ADDENDUM NO. 5

DATE: March 18, 2020

PROJECT: Hammond High School Renovation and Addition
Columbia, Maryland
Architect Project No. 18011

4 M2.11 FIRST FLOOR PLAN - TEMPORARY LOCKER ROOM
SCALE: 1/8" = 1'-0"

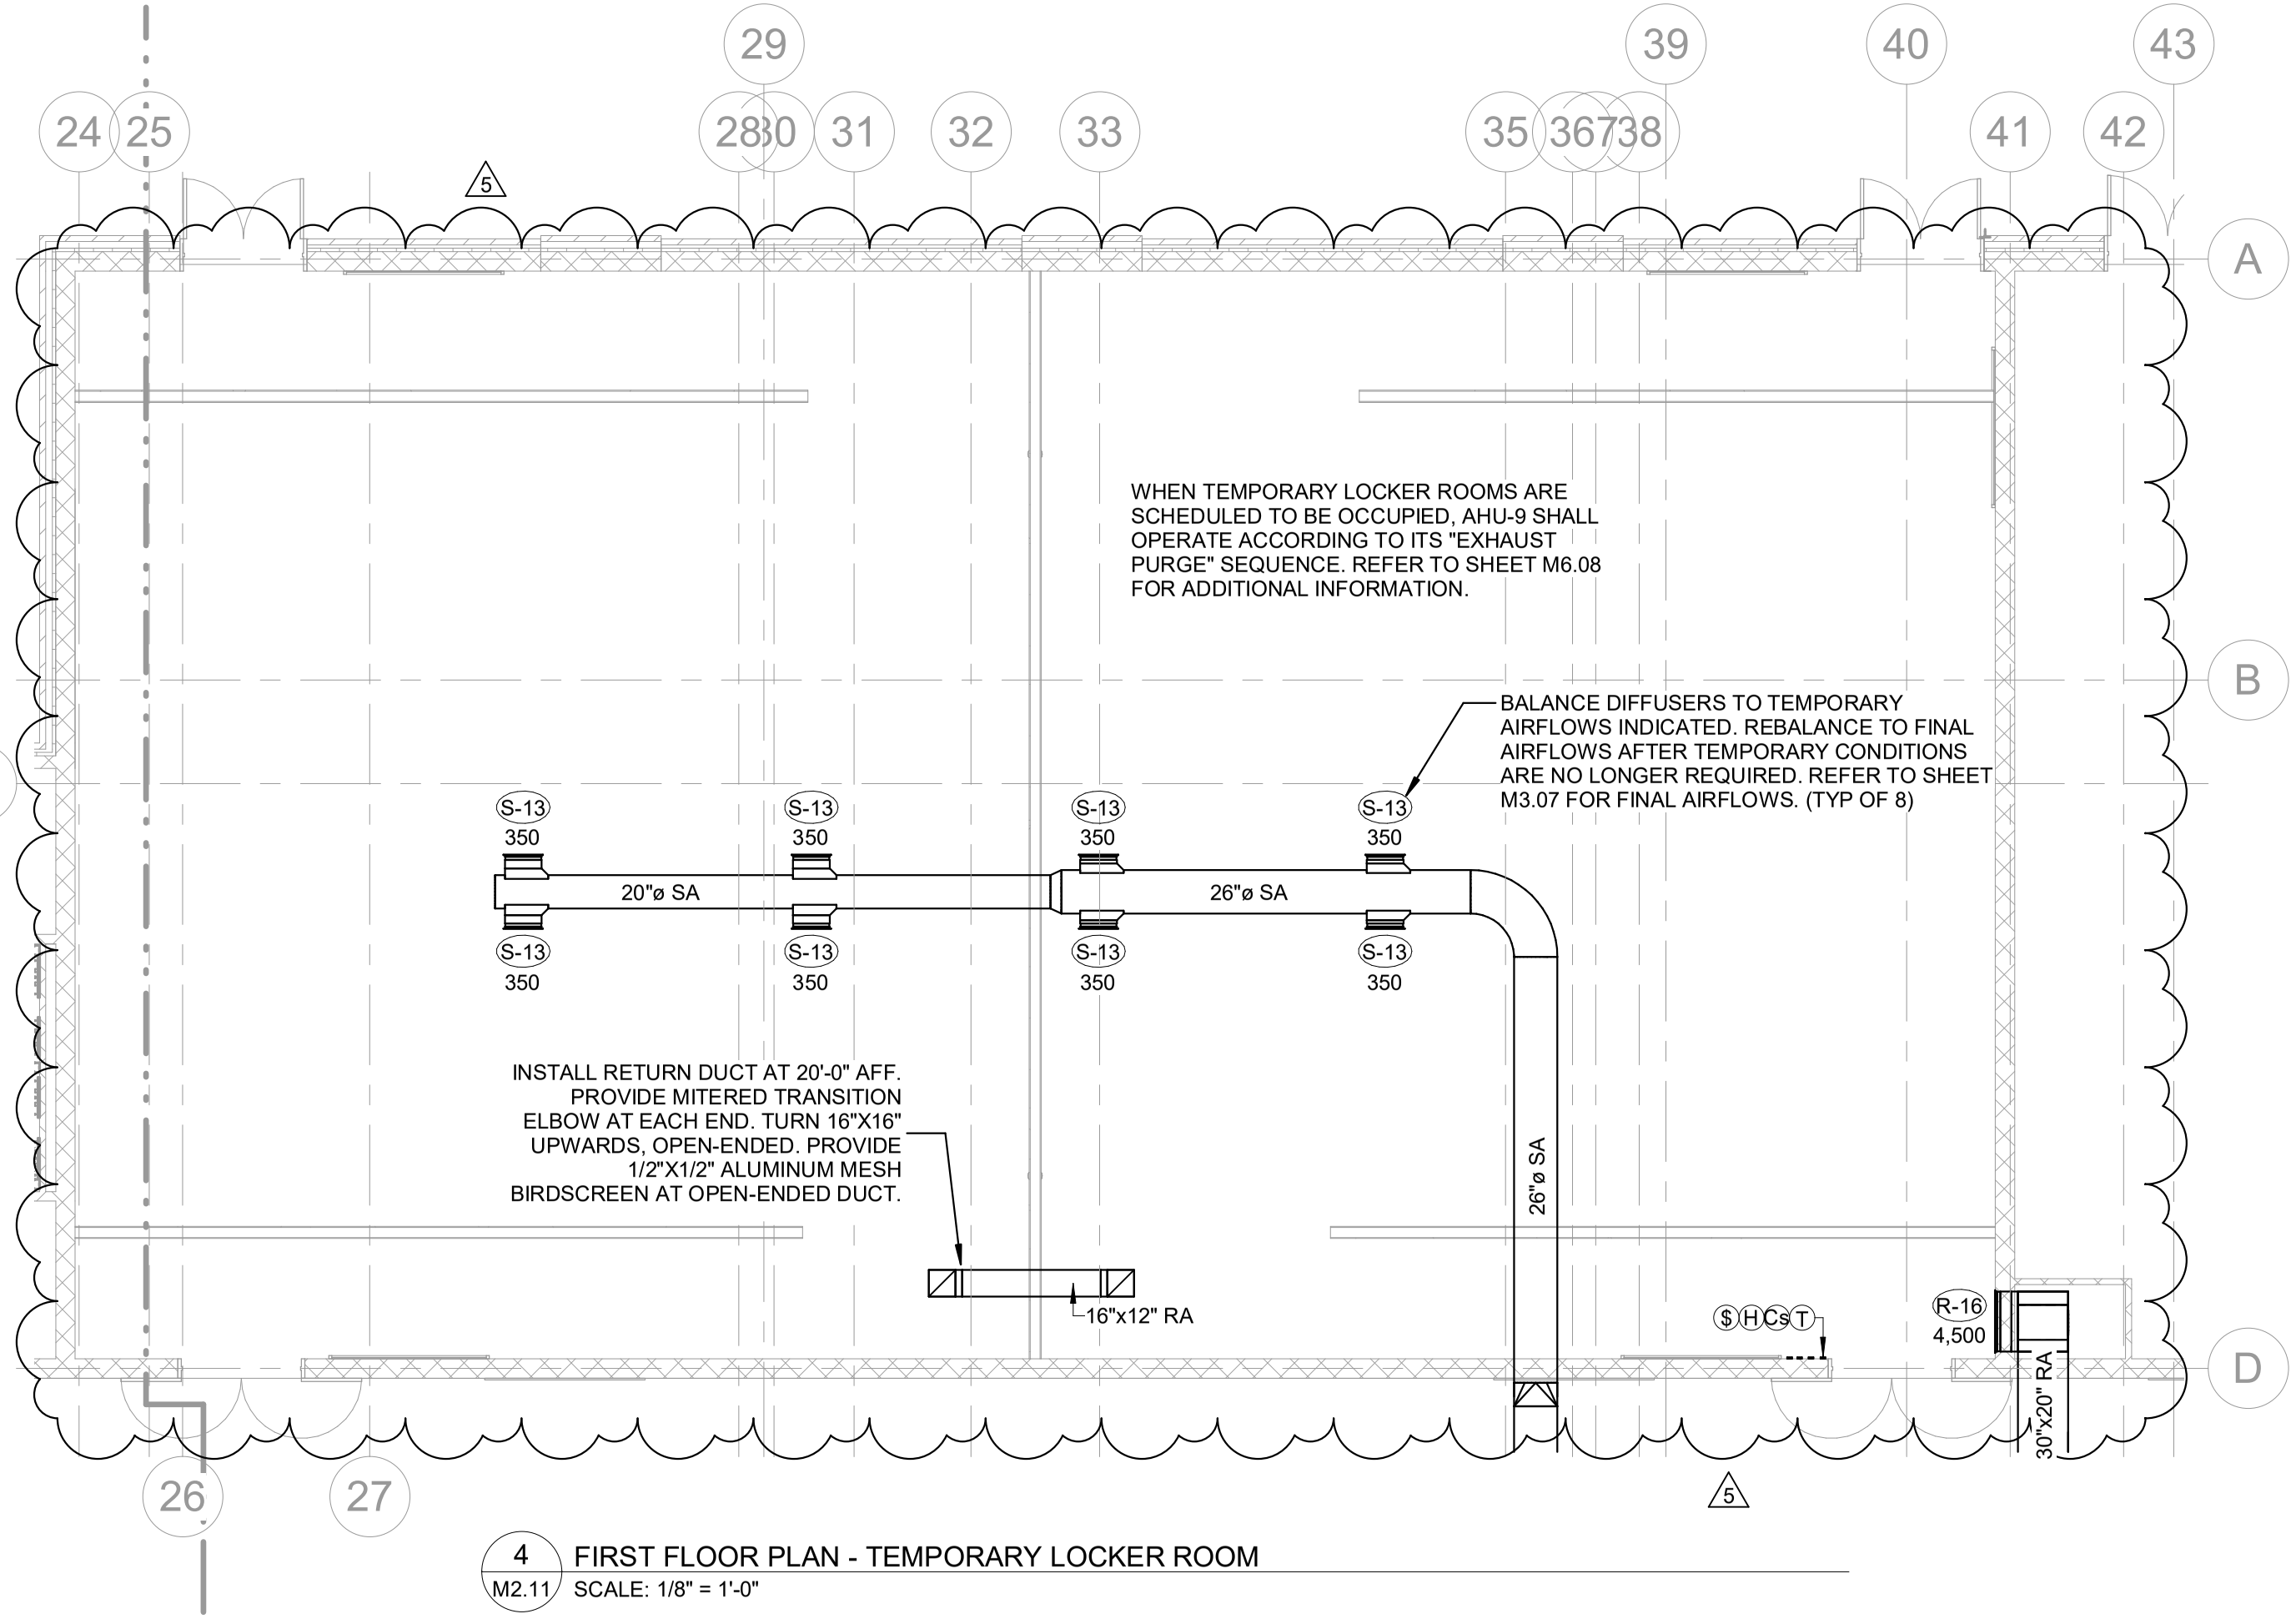
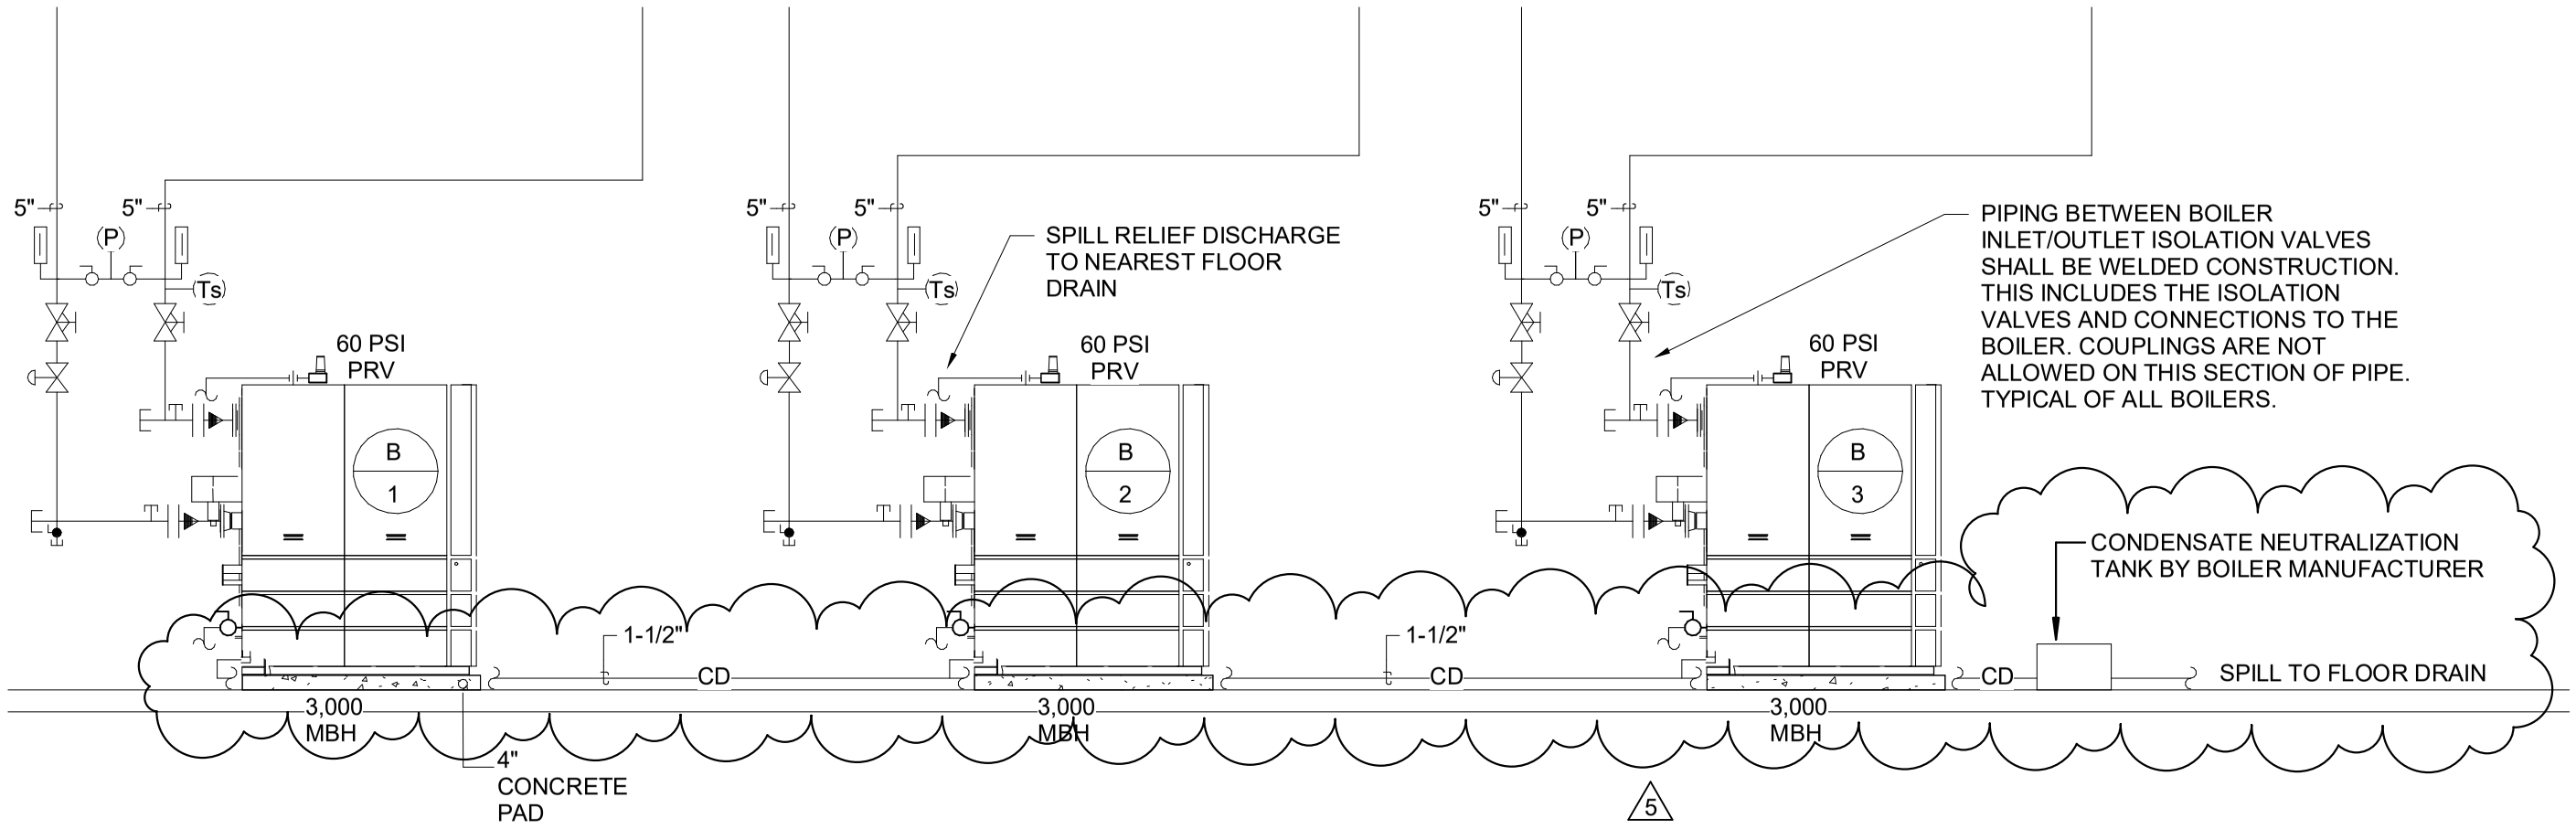
- ❑ Sheet M2.11 – TEMPORARY CONDITIONS – MECHANICAL
  - **ADD** FIRST FLOOR PLAN – TEMPORARY LOCKER ROOM view to Sheet M2.11. See addendum drawing AD-M23.
- ❑ Sheet M3.02 – FIRST FLOOR PLAN – AREA B – MECHANICAL
  - **ADD** humidity sensor to MEDIA CENTER B127, install adjacent to thermostat/CO2 sensor.
- ❑ Sheet M3.03 – FIRST FLOOR PLAN – AREA C – MECHANICAL
  - **ADD** humidity sensor to KITCHEN C102, install adjacent to thermostat/CO2 sensor.
  - **ADD** humidity sensor to CAFETERIA C101, install adjacent to thermostat/CO2 sensor.
  - **ADD** Keynote A68 to AC-2 in MDF C112.

1 A2.09 AREA H - SECOND FLOOR
SCALE: 1/8" = 1'-0"

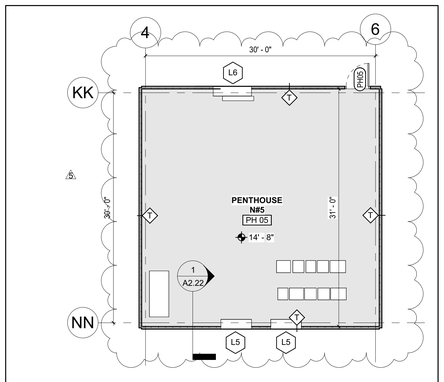
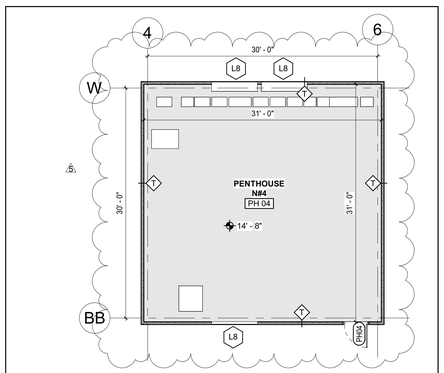
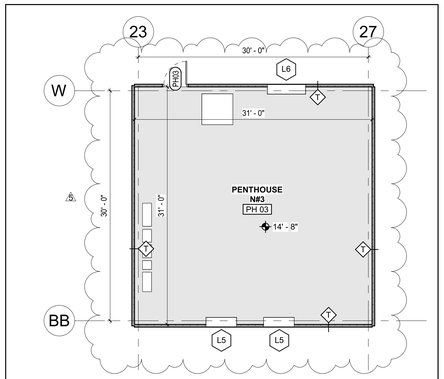
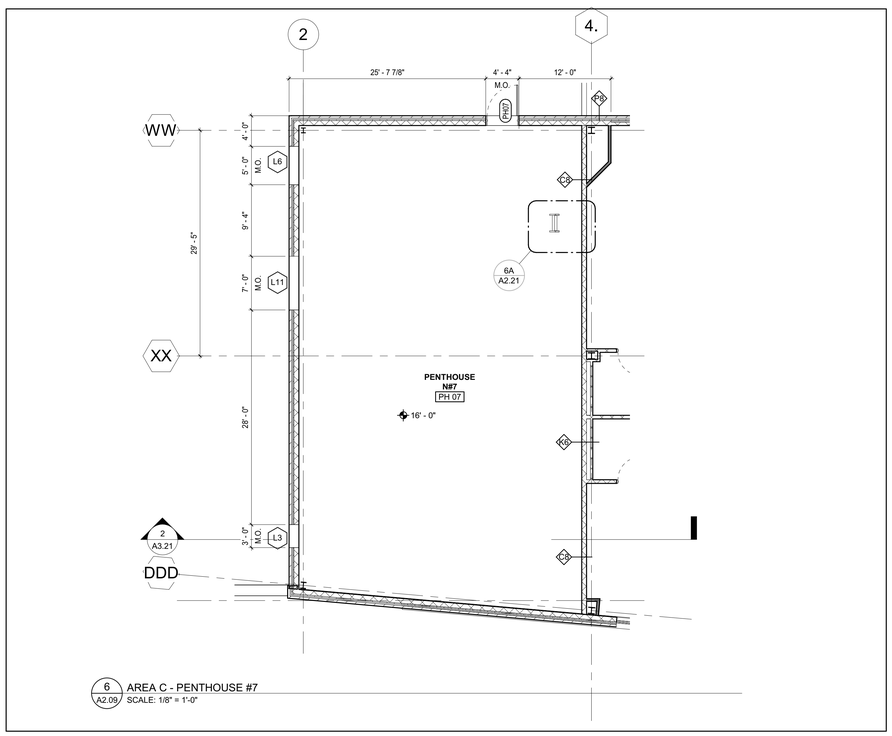
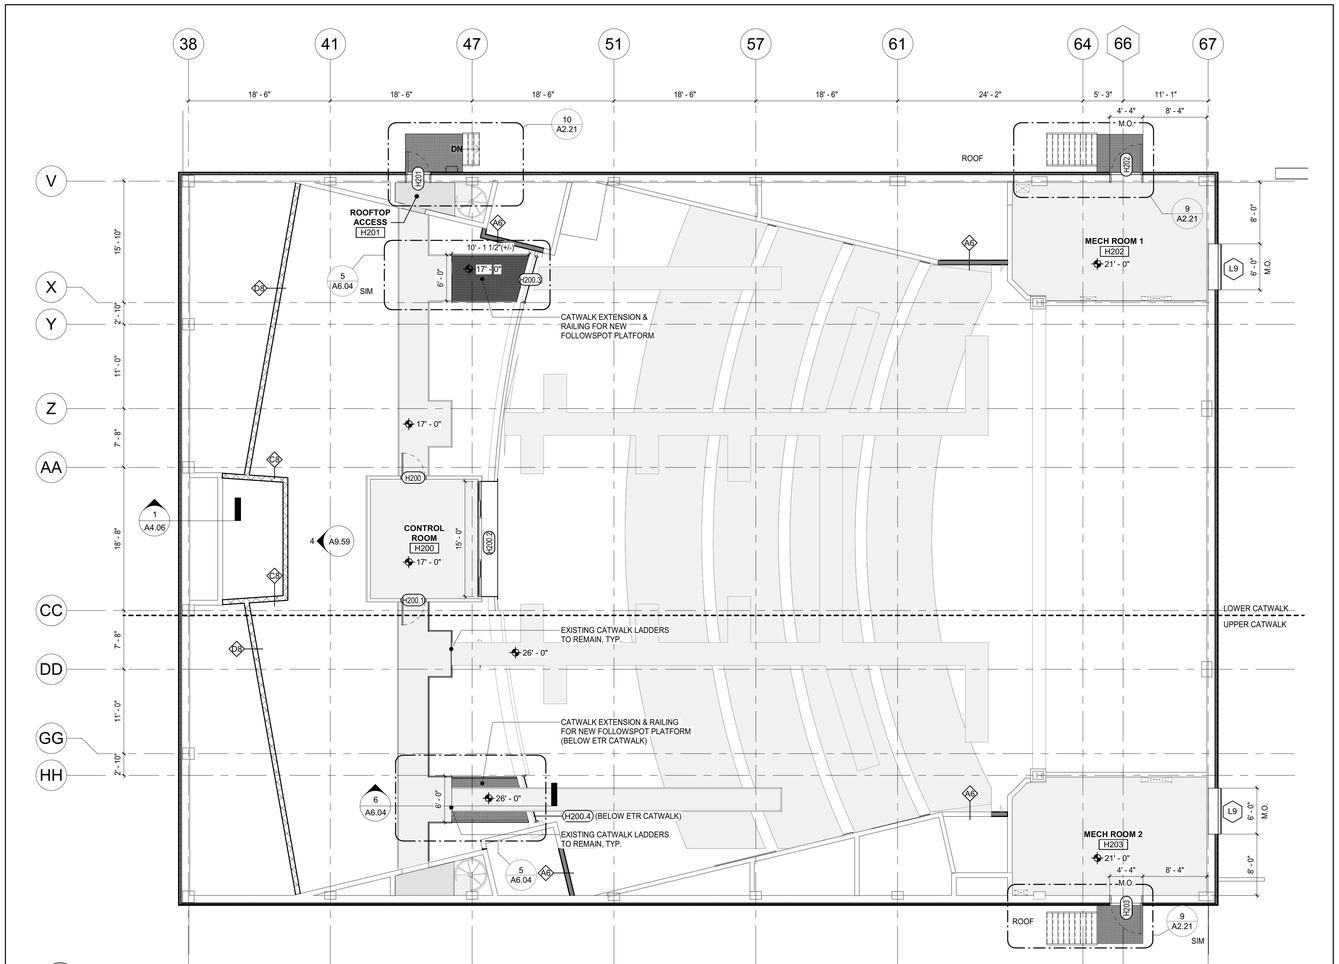
- ❑ A0.50 - OVERALL PHASING PLAN
  - **REVISE** detail 2/A0.50 to modify phasing of tubular daylighting devices as shown in sketch AD-A09
- ❑ A2.09 – FLOOR PLAN - FLOOR 2 - AREA H & PENTHOUSES 3, 4, 5, 6 & 7

- **REVISE** floor hatching to clarify existing vs. new concrete work in penthouses. See reissued sheet.
- ❑ A2.57 – RCP – FLOOR 1 – AREA H
  - **REVISE** ceiling in stage wings and existing spiral staircases as shown in sketch AD-A11

EXISTING DANCE STUDIO ROOFTOP UNIT

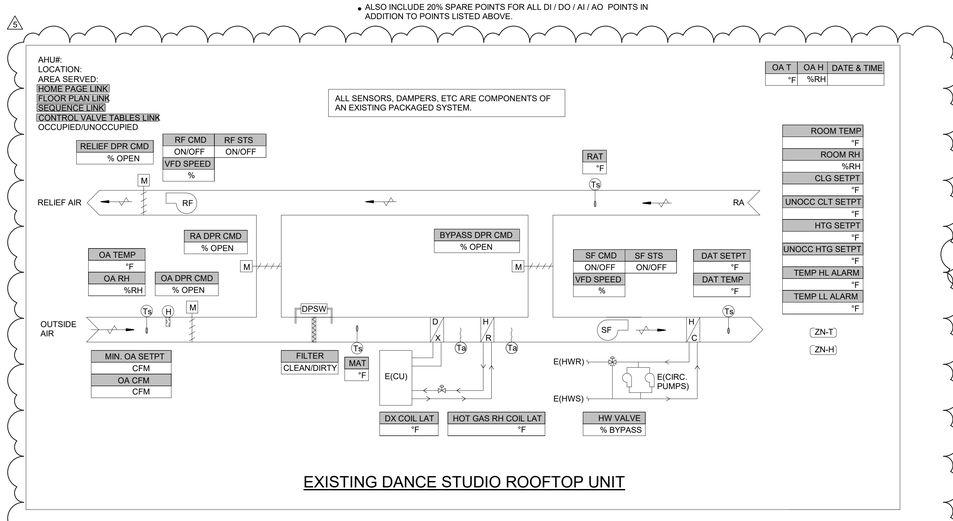
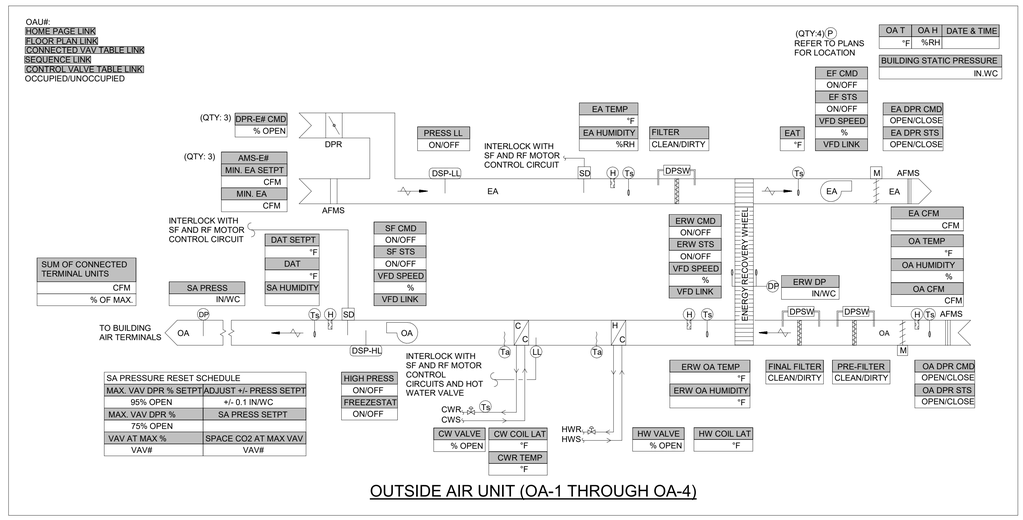
- **REPLACE SHEET** M6.11. **ADD** controls schematic, sequence, and points list for Existing Dance Studio Rooftop Unit (RTU). **REMOVE** note 3 from the OUTSIDE AIR HANDLING UNIT (OA-1 THROUGH OA-4) control sequence. **REVISE** note 6. EXHAUST FAN CONTROL (previously note 7) in the OUTSIDE AIR HANDLING UNIT (OA-1 THROUGH OA-4) control sequence. **REVISE** OUTSIDE AIR SYSTEM points list. Provide EXHAUST AIR CFM in lieu of RELIEF AIR CFM.
